OPERATIONAL SAFETY RECOMMENDATIONS

Reference: REC 12/21, REC 13/21, REC 14/21 y REC 15/21

Investigation A-011/2021, opened by the Civil Aviation Accident and Incident Investigation Commission, has found that:

Figure 1. Photographs of the exhaust area of cylinder no. 4 (left) and of the elements that were found loose (right)

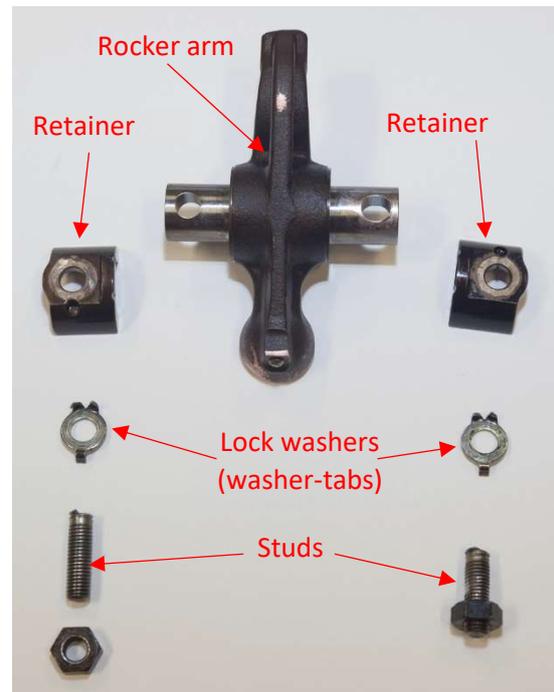
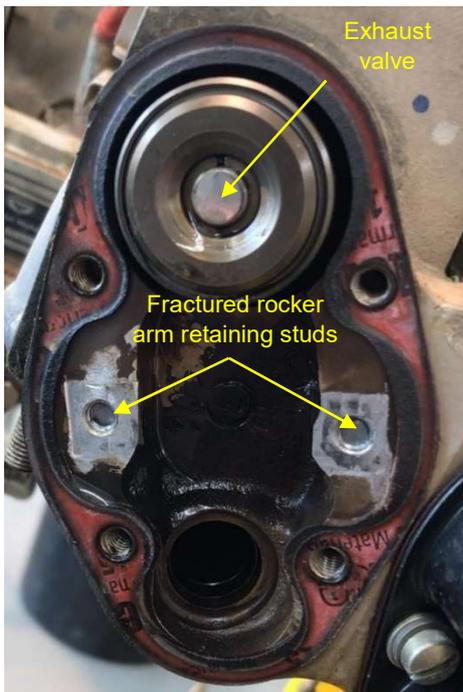
- The shaft remained assembled in the rocker arm housing. The two washers on each side of the rocker arm were also in position.
- The retainers were loose but showed no signs of significant damage.
- The two stud bolts that hold the retainers had fractured at the point where they enter the cylinder head (figure 1 – left photograph).

- One of them had its threaded nut, and the other did not.
- The threads on the stud bolt that did not have the threaded nut showed no significant damage. Its missing nut was found entirely separated from the stud with its threads in good condition.
- The two lock washers were also found detached, intact, and with no appreciable damage.

The fact that a loose, unscrewed nut was found without damage to the threads of either the stud or the nut suggests it gradually unscrewed itself.

The purpose of the lock washer is to prevent the nut from working its way loose during engine operation. The fact that the nut had done so suggests the washer did not serve its purpose. Given that there were no signs of any significant damage that might have affected its performance, the most probable hypothesis is that the washer was incorrectly installed.

Figure 2. Photograph of exhaust valve rocker arm cylinder no. 3, engine IO-240-B32, s/n: 1035257.

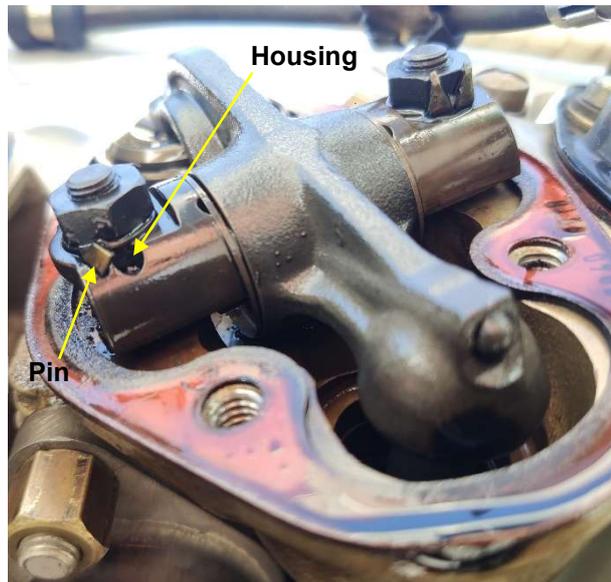
We found that one of the retainer nut lock washers in the exhaust valve of cylinder no.3 was incorrectly installed, as the pin had not been inserted into the retainer housing (see figure 2).

If the pin is not inserted into the housing, the washer doesn't brake the nut effectively and, therefore, it could come loose.

REC 13/21: It is recommended that Continental Motors, Inc. should implement measures to ensure the correct installation of the lock washers.

REC 15/21: It is recommended that Continental Motors, Inc. should contact all operators of aircraft equipped with engines potentially affected by this problem in order to verify the extent of the problem and, where necessary, replace the defective washers.
